ADDENDUM #1

11/17/2025

Etna High Point Park Site Improvements Project

PROJECT c24232

3 THREE-RAIL FENCE
SCALE: 3/4" = 1'-0"

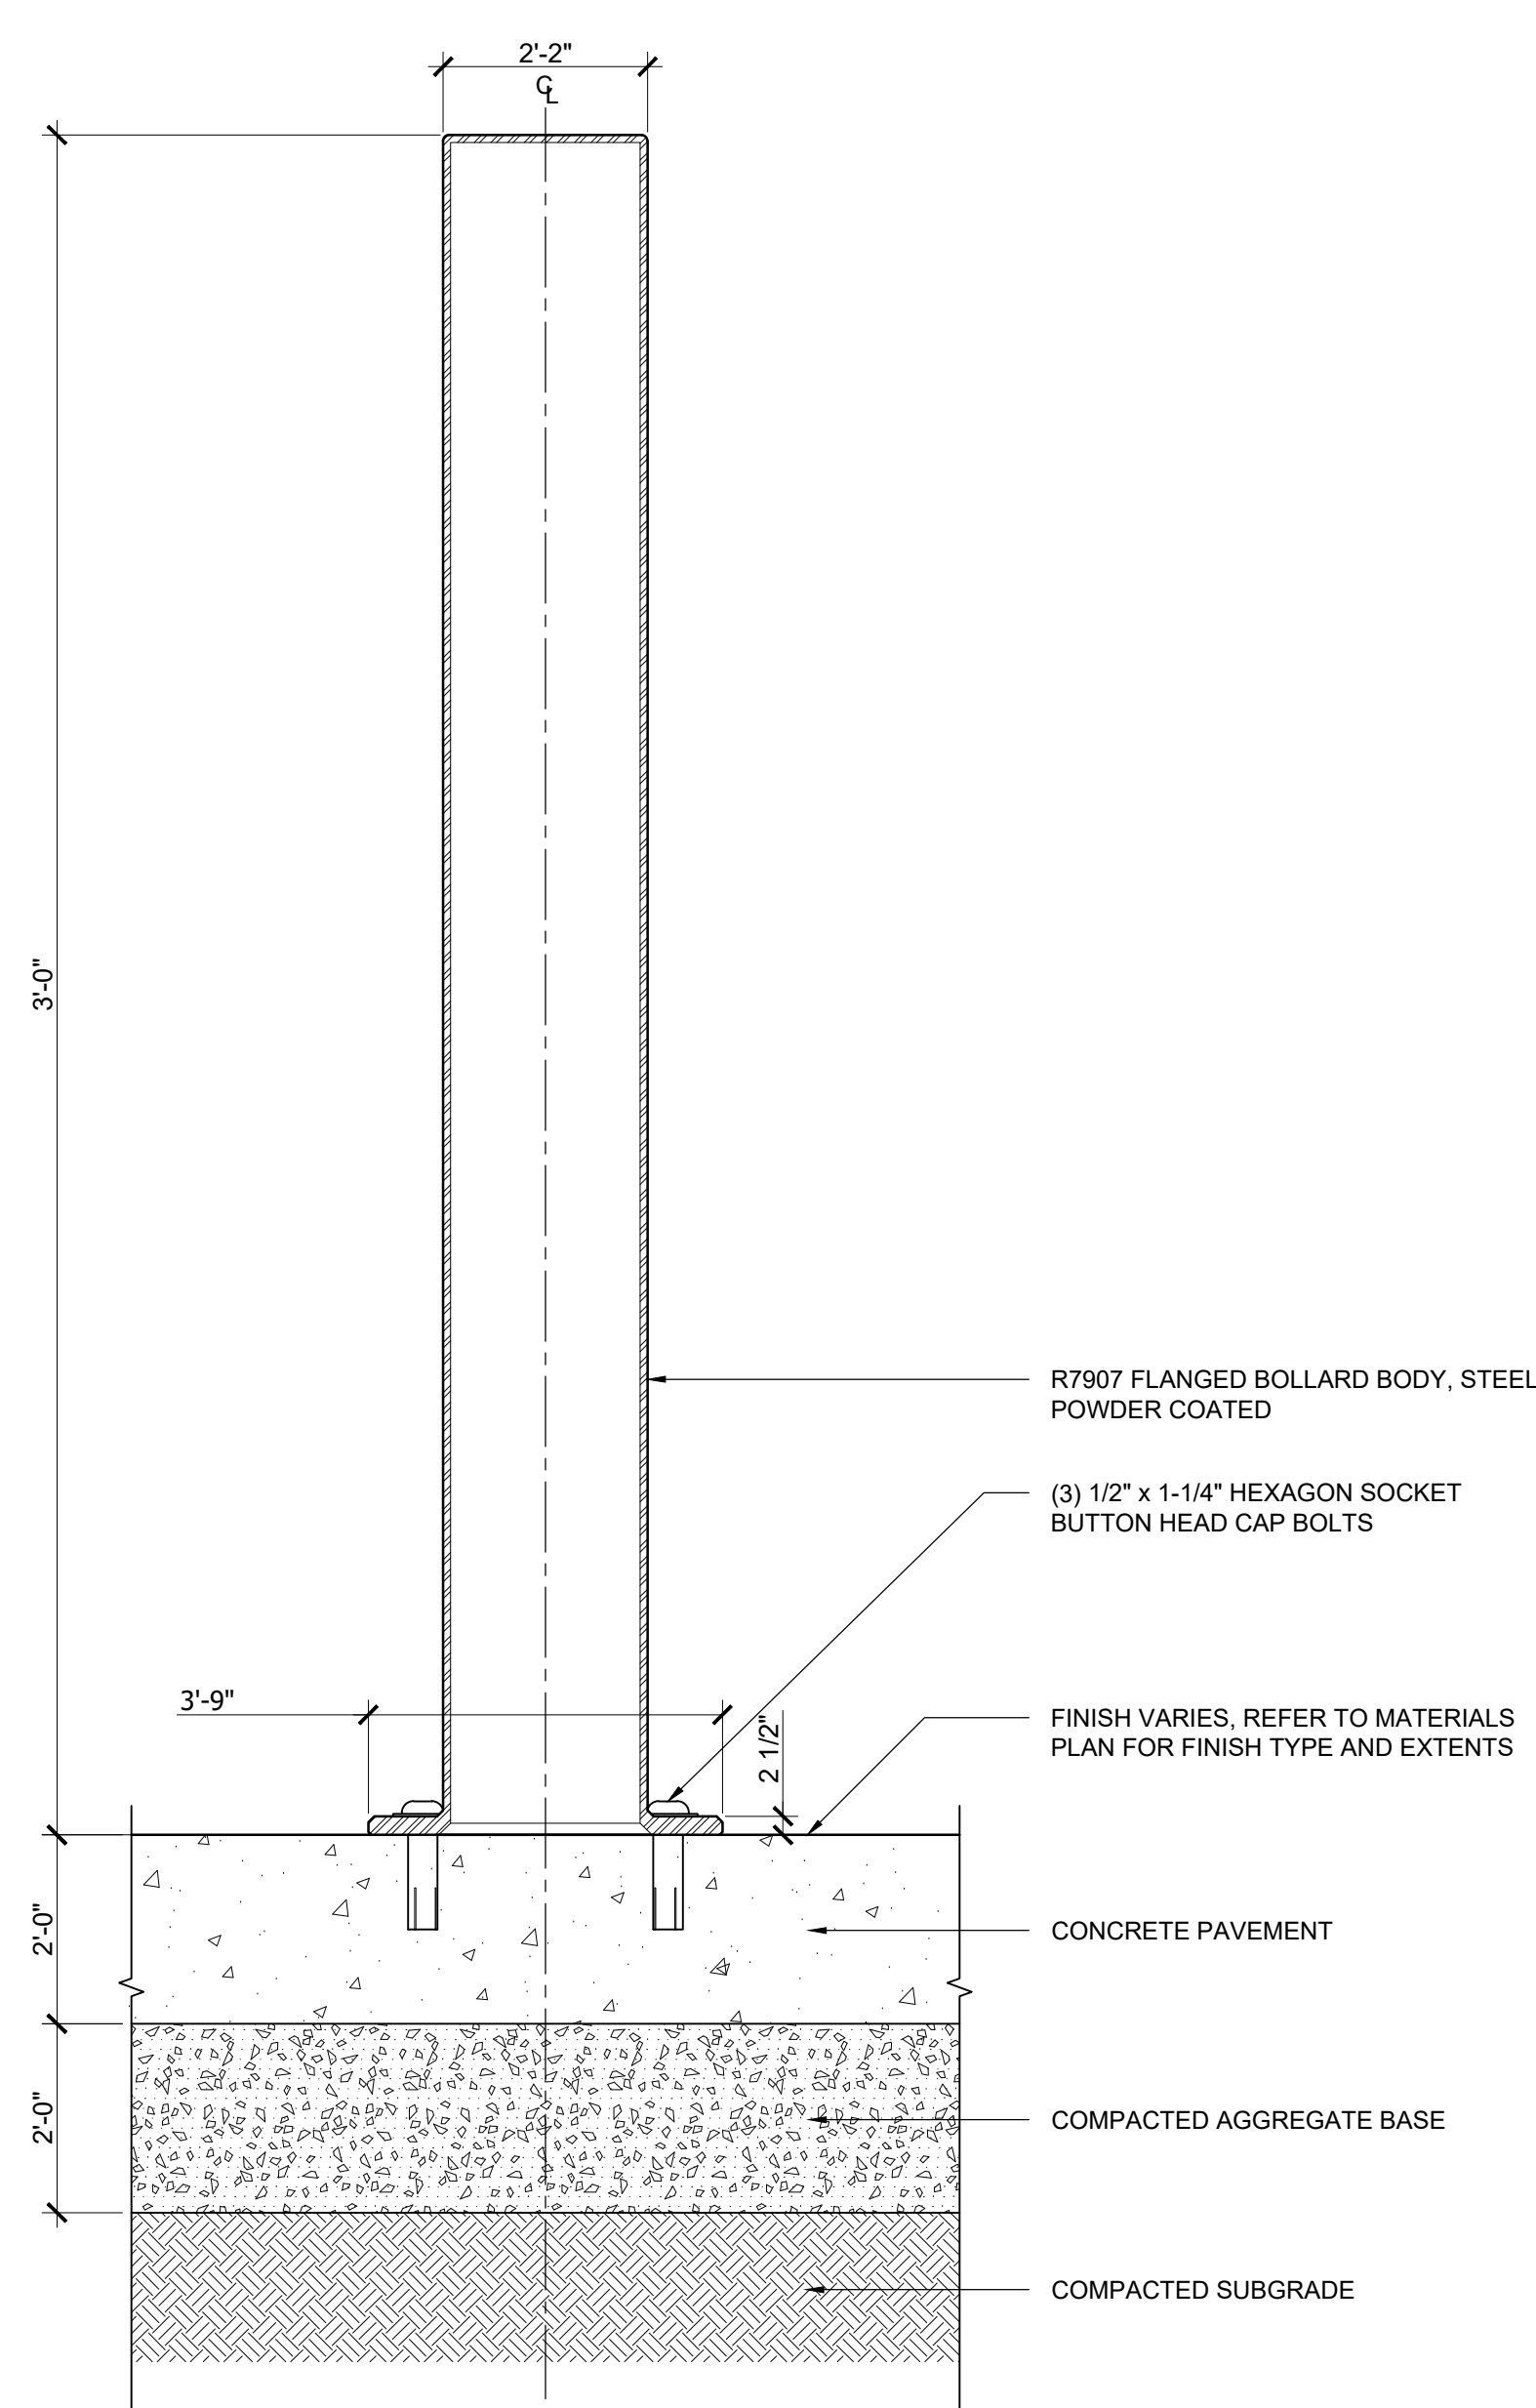
- C. SHEET L4.02:
 - a. Updated the board dimensions on detail 3/ L4.02 to 1"x8" and 1"x6"
 - b. Updated the board dimensions on detail 4/ L4.02 to 1"x8" and 1"x6"
- D. SHEET E0.01:
 - a. Updated luminaire schedule as shown per RFI responses.

A SITE PLAN
NEW WORK

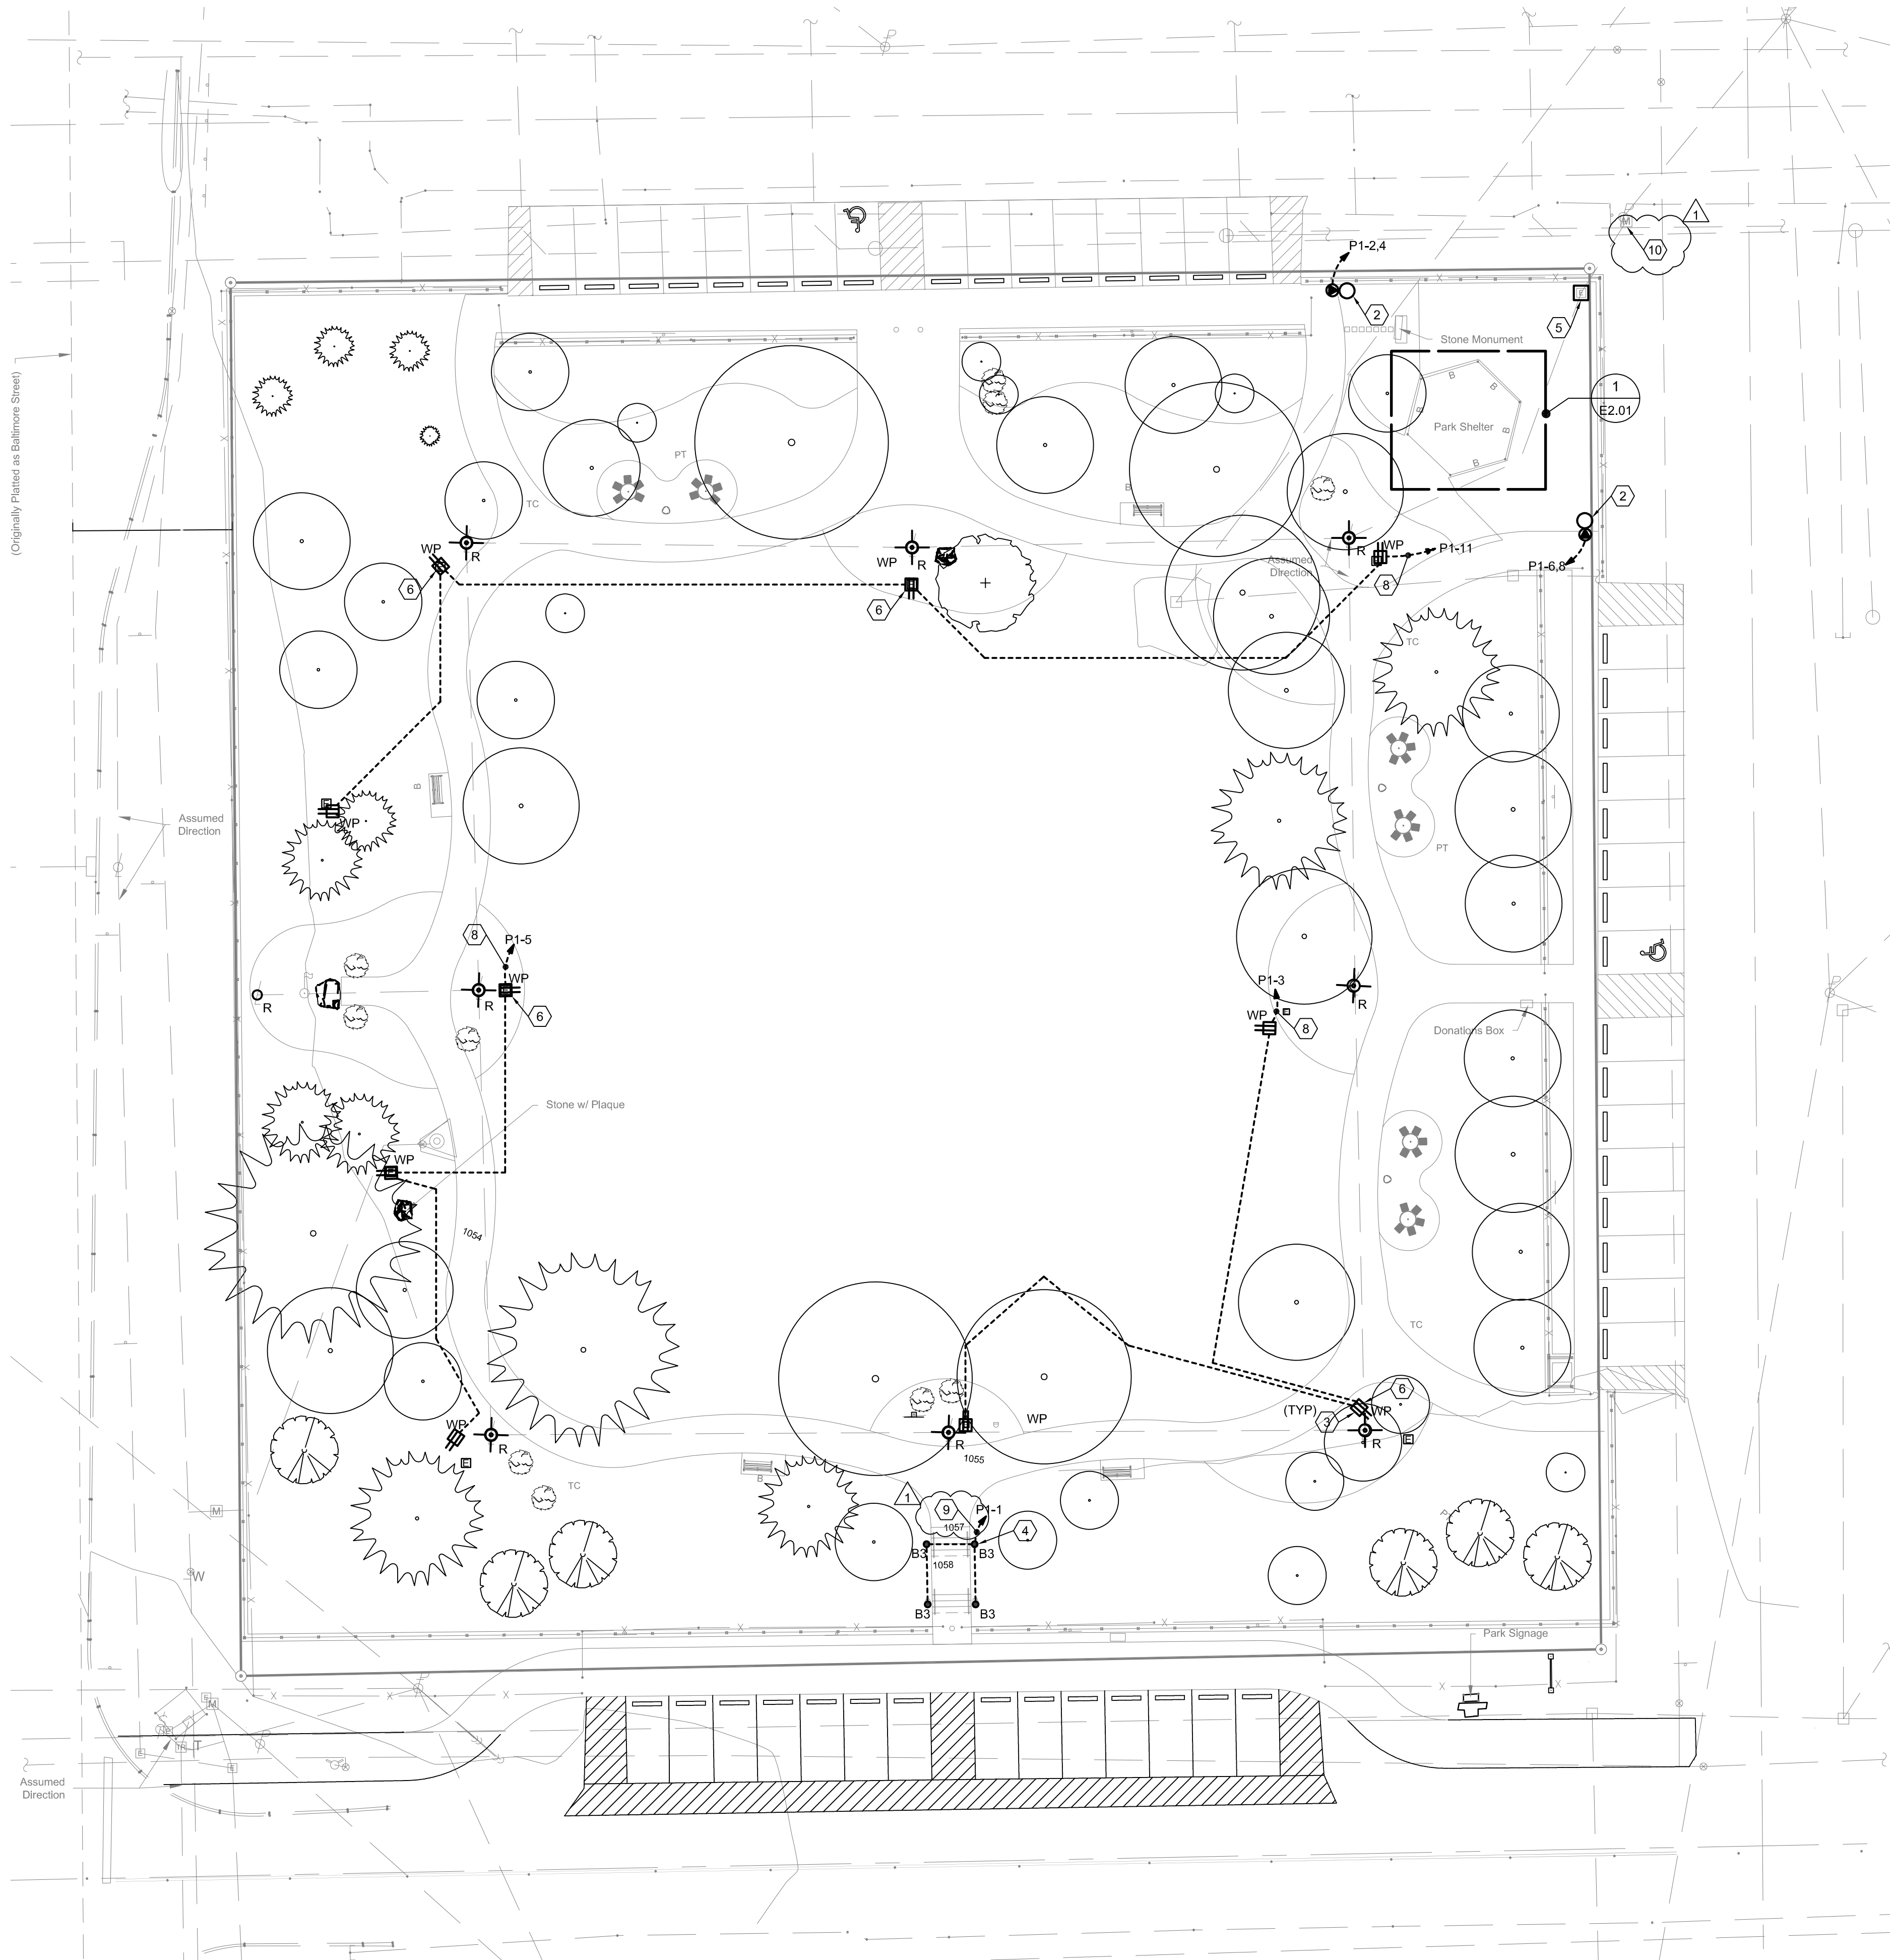
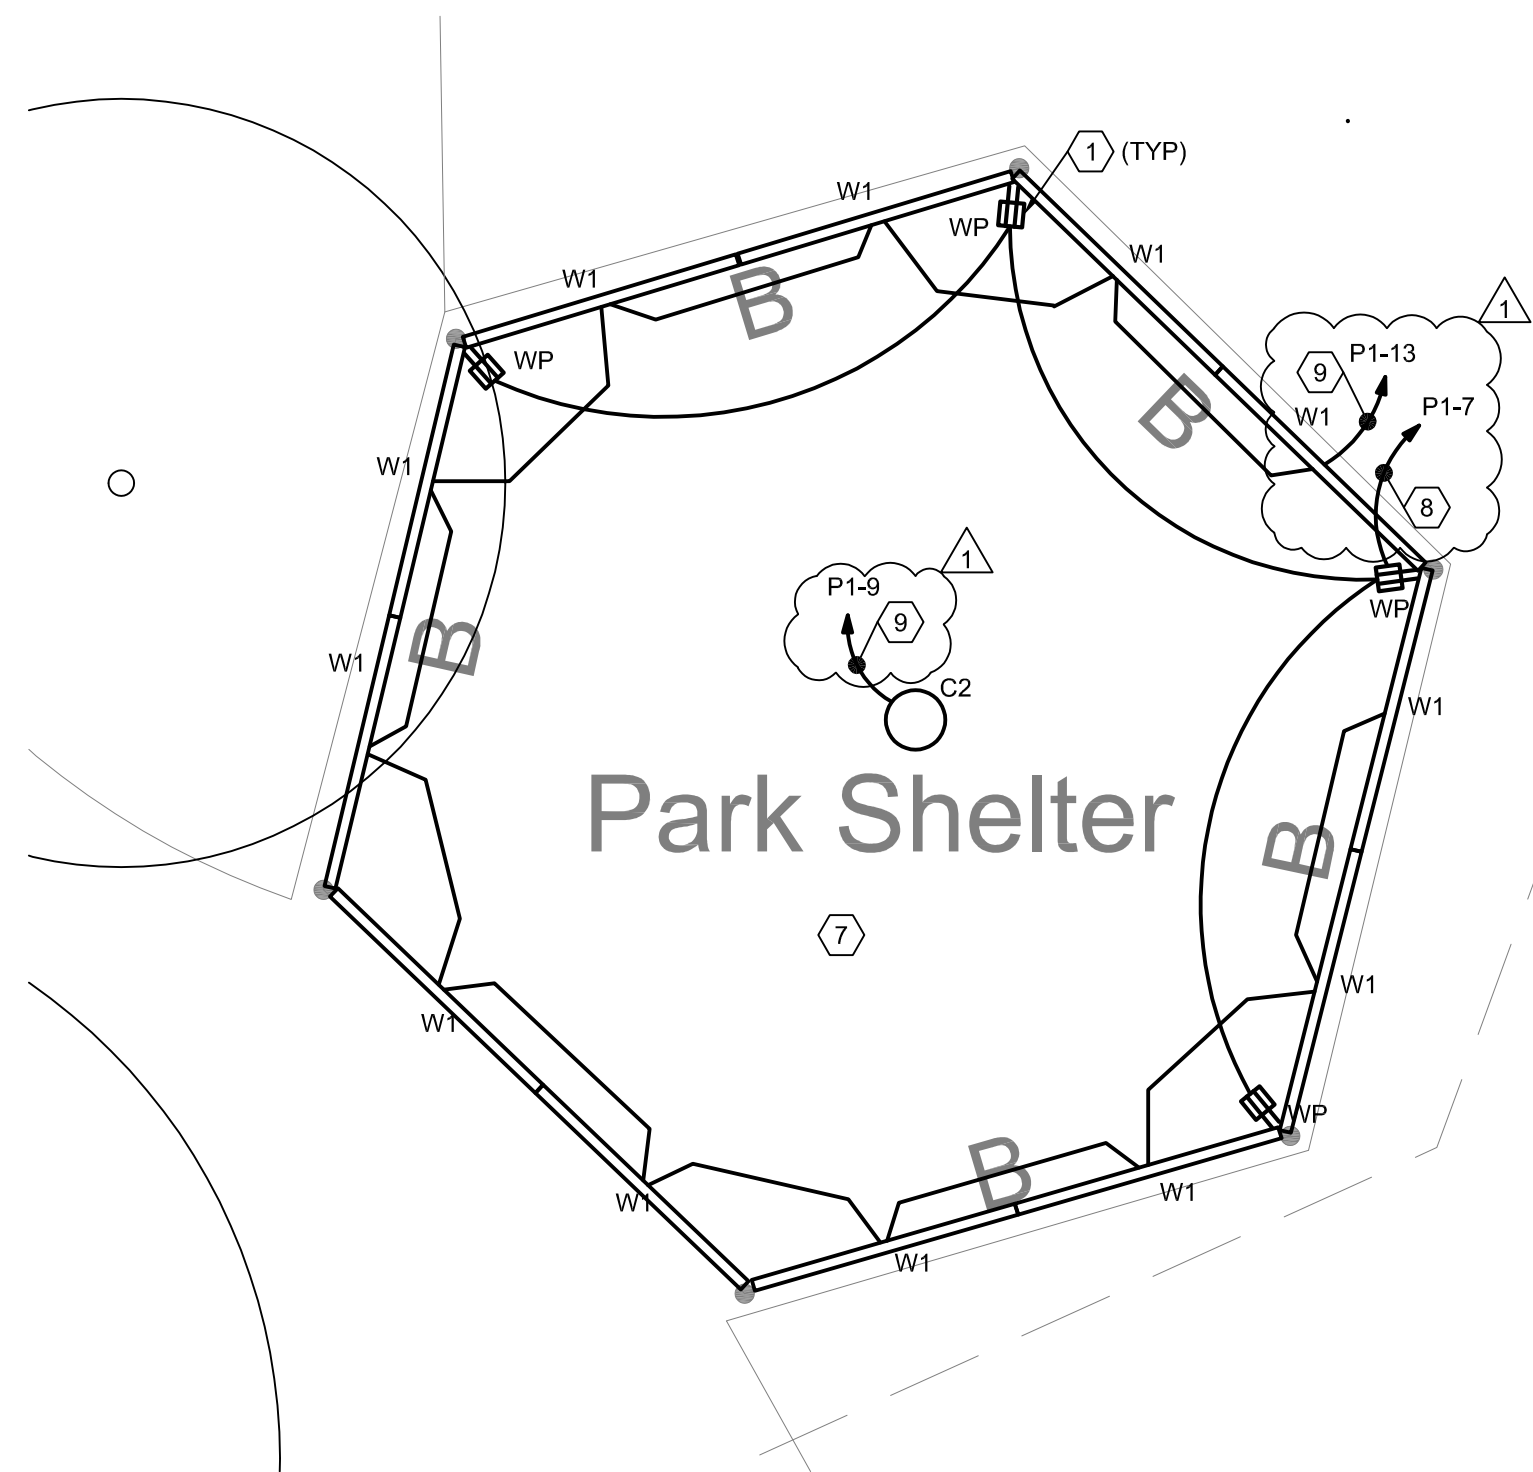
E. SHEET E2.01:

- a. Revised coded notes on branch circuit home-runs throughout the site to clarify which lighting contactor circuits should extend through.
- b. Revised general and coded notes to change Milbank enclosure to generic specification of products in a pad-mounted weatherproof enclosure and define all elements to be installed within that enclosure.
- c. Revised general and coded notes to clarify contactors for controls.

8. EXTEND CIRCUIT THROUGH LIGHTING CONTACTOR LC1 IN ELECTRICAL EQUIPMENT ENCLOSURE FOR TIME OF DAY CONTROL.
9. EXTEND CIRCUIT THROUGH LIGHTING CONTACTOR LC2 IN ELECTRICAL EQUIPMENT ENCLOSURE FOR TIME OF DAY CONTROL.
